Groundwater Application Review Summary Form

Application # G- 19340

PUBLIC INTEREST REVIEW FOR GROUNDWATER APPLICATIONS

A. GENERAL INFORMATION: Applicant's Name: Northwest Botanica, LLC Attn: Carlos Quintana
 County: Washington

Water-Level Measurements in Nearby Wells

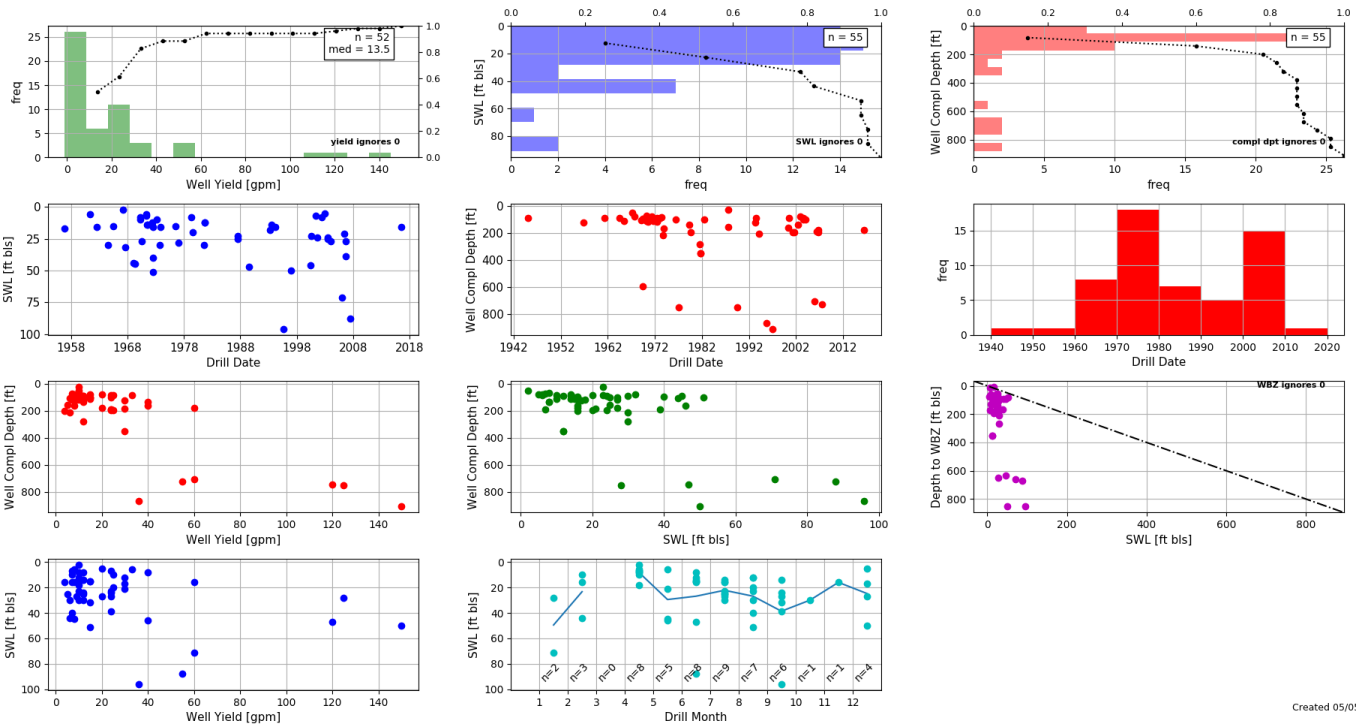
Six wells near the proposed POA with sufficient water level data were selected for evaluation: WASH 51664, WASH 5366, WASH 5377, WASH 7239, WASH 57263, and WASH 5139. The observation wells demonstrate a similar decline up to 25 feet from the late 1990's through the mid-2000's. Water levels then show disparate behavior, with some demonstrating variability of 10 to 20 feet. One observation well (WASH 7239) demonstrates consistent decline, totaling nearly 30 feet from the mid-1990's to present. The most proximal observation wells with similar open intervals and water level elevation to the proposed POA (WASH 5366 and WASH 5377) show highly variable water level behavior, with approximately 20 feet of variation over approximately 20 years, but no obvious or persistent decline. Due to the very low rate of requested withdrawal, the proposed use is considered within the capacity of the resource. However, in order to protect senior users and the resource, Condition 7i is strongly recommended for any permit issued pursuant to this application.
